Forest Bridge Capacity Signage

A technical review and operational discussion of the FLNRO
Engineering Branch 'road load rating' concept

May 19, 2015

Figure 1: Max shear force comparison for simple span forest bridges. Unfactored L-75 design load vs. short truck at specified load limit.

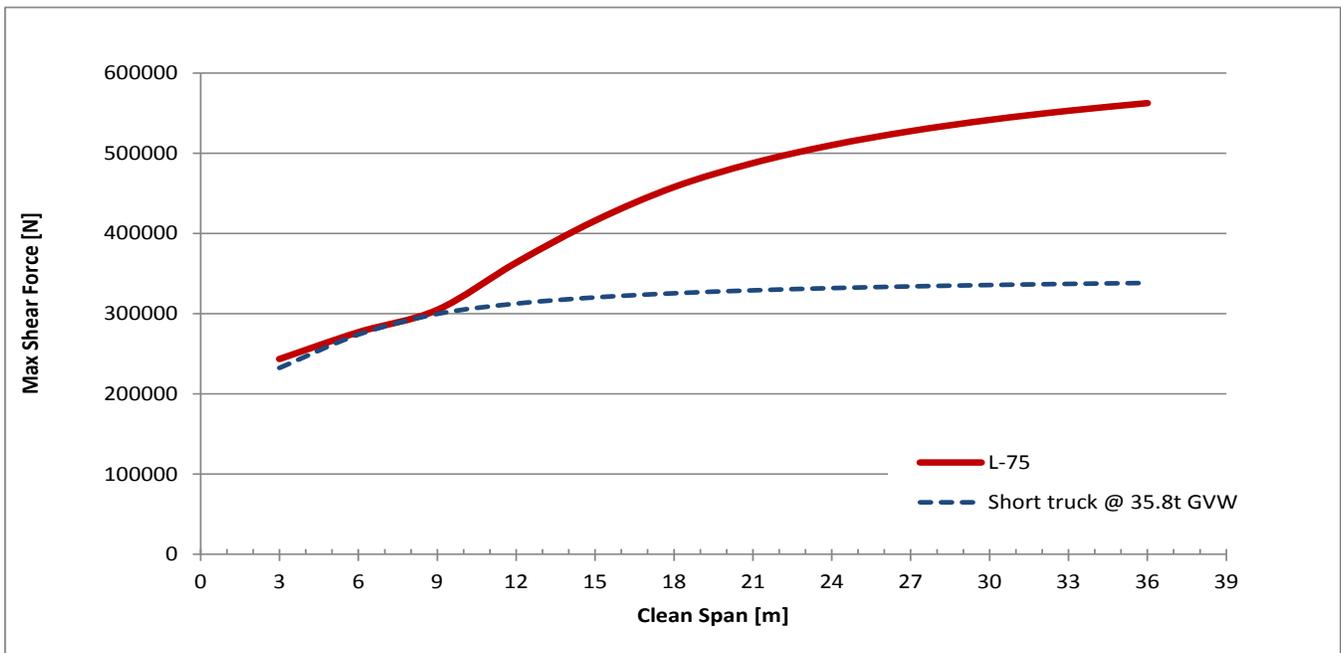
In all cases and for each span considered, the force effects calculated for the short truck with the load limit specified in Table 4 did not exceed the force effects from the design vehicle. Figures 1 and 2 illustrate the calculated force effects over a range of spans for the short truck versus the L-75 design load. In the case of the L-75 bridge design the short truck with a 35.8 t GVW was close to exceeding both the shear and moment of the bridge design vehicle. When the short truck was increased by 0.5 t its shear and bending moment exceeded that of the L-75 design vehicle. All of the McClelland (2013) short truck load limits given in Table 4 were found to be accurately estimated; and, when the short truck GVW was increased by 0.5 to 1.0 t the design vehicle force effects (shear or bending moment) were exceeded in every case.

Figure 3: Max shear force comparison for 2-girder simple span forest bridges. Unfactored LOH design load vs. tracked equipment at specified load limit.

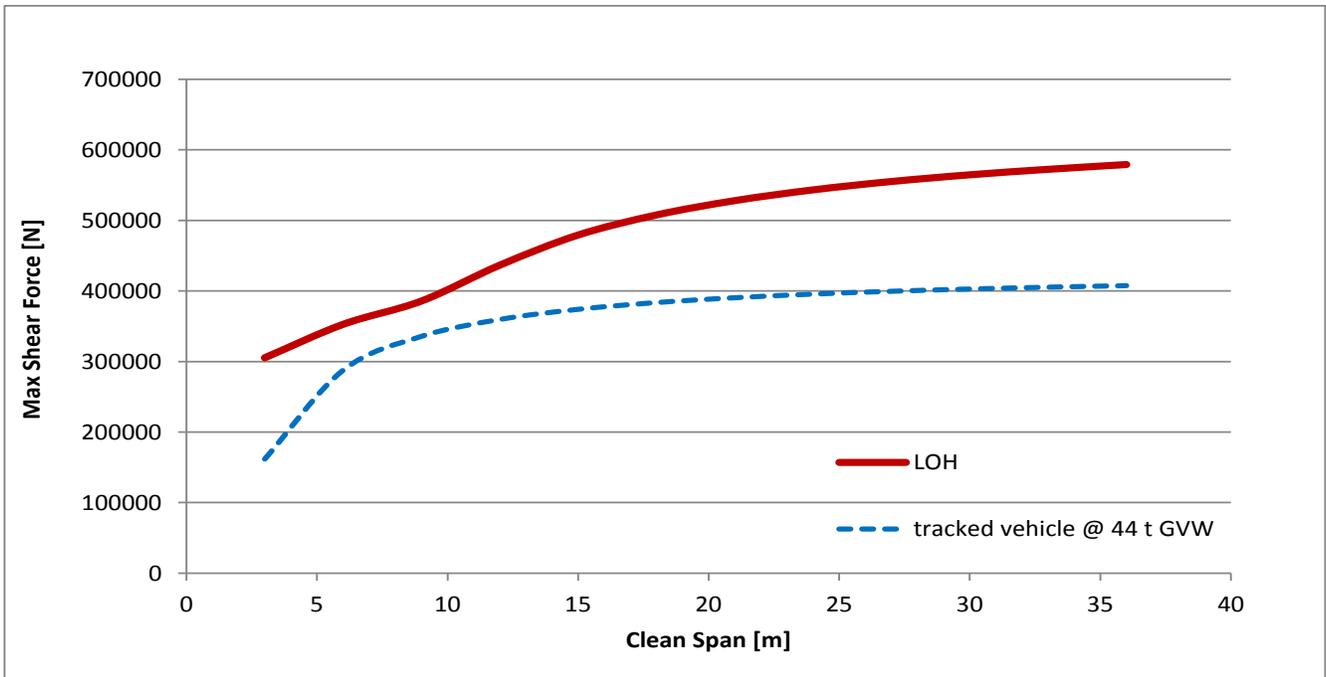
The tracked equipment load limits were re-calculated for typical 2-girder forest bridges using a lower live load factor than used in McClelland (2013) (i.e., 1.30 vs 2.0). This increased load limits by approximately 54% over those in McClelland (2013). Tracked equipment load limits also were calculated for slab type and gravel-over-log-stringer forest bridges using the same live load factor, but lower DLA and distribution factors (see Appendix 1). Figures 3 and 4 illustrate the calculated force effects of the tracked equipment versus the L-75 design load for a range of simple spans. As can be seen, the tracked equipment load limit was governed by its bending moment rather than its shear.

Recommendation: that the lower of the two tracked vehicle load limits (for slab and log stringer bridges) be used for posting design bridge limits, in general. Bridge designers should be informed about the higher load limits that apply to typical 2-girder forestry bridges so that these could be used on networks with no concrete slab or log stringer bridges, or existing log stringer bridges can be individually load rated. In addition, given the importance to industry and the Ministry, further investigation into the load limits for concrete slab bridges and into the DLA for log stringer bridges should be undertaken.

Figure 7. Suggested L-45 road network load limit sign based on the lesser of the short truck and tracked equipment load limits.

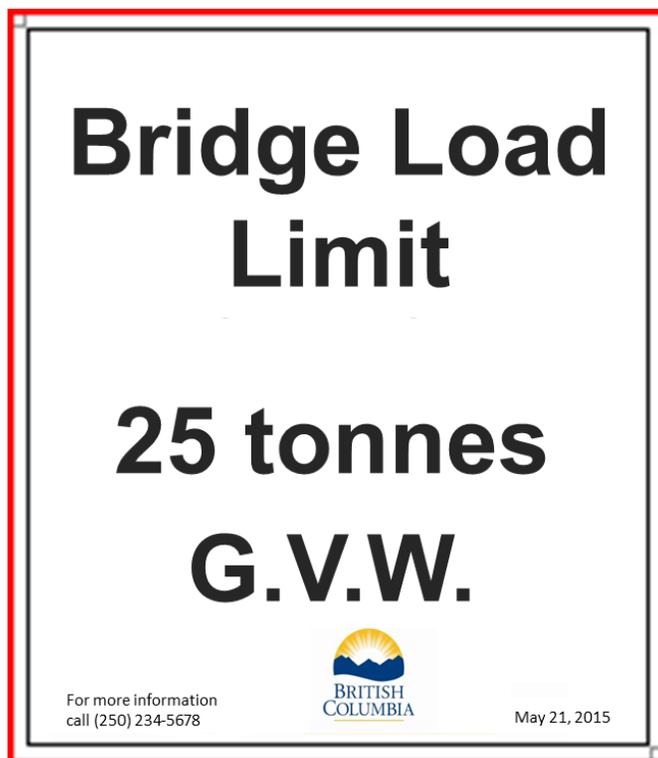
L-45 bridges: As mentioned in the preceding discussion, L-45 bridge load limits in Table 5 are too small to accommodate most legally loaded log hauling trucks but would be sufficient for a variety of short trucks and tracked vehicles. Rather than show load limits that are less than legal limits, it may be preferable to show a single bridge load limit based on the lesser of the 25.5-t short truck GVW and the 25-t tracked equipment GVW (Figure 7). As the 25 tonnes is much less than the weight of any loaded log hauling vehicle this should discourage these vehicle from using the bridge.

Figure 8. Suggested full posting road load sign for an L-100 FSR network. Use the same full posting format for L-60, BCL-625, L-75, LOH, HOH, L-150, and L-165 networks.

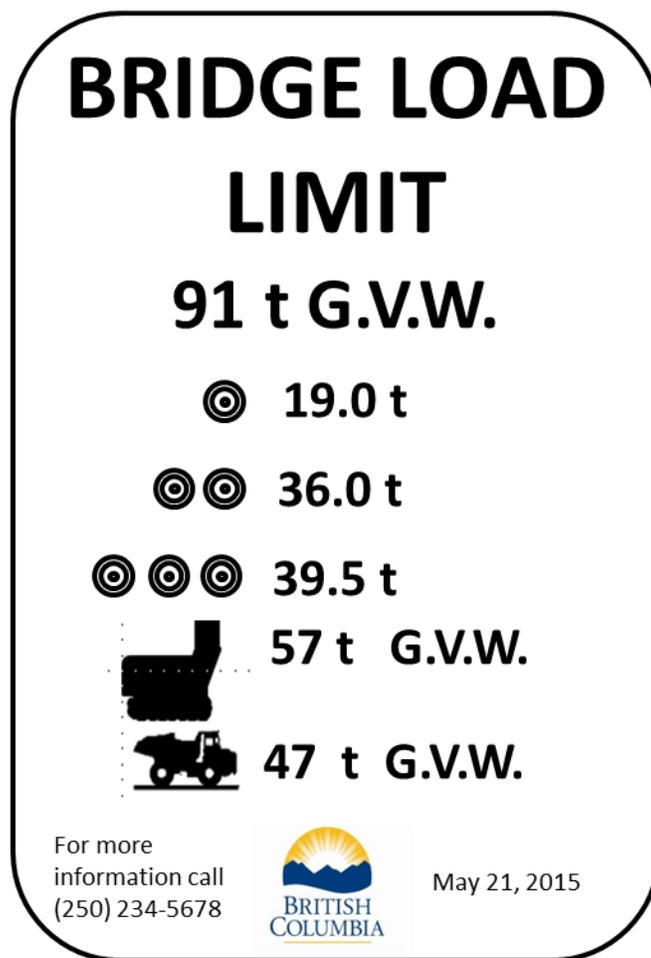
L-75 to L-165 bridges: It is suggested that these bridge capacities be represented with a full posting (GVW, axle group weight load limits, short truck GVW, and tracked equipment GVW). This sign could be as shown in Figure 8 provided that all of the bridges on the network are typical 2-girder forest bridges. If there are both 2-girder and slab or gravel-over-log-stringer bridges then both load limits for tracked vehicles should be shown on the sign or just the lesser of the two.

Recommendation: Ministry develop standard signage for bridge capacity with a sign (Figure 8) that combines GVW, axle group weight load limits, short truck GVW, and tracked equipment GVW. Alternately, if axle group load limits are less than legal limits, show only a single GVW limit that is the lesser of the short truck GVW and tracked equipment GVW.
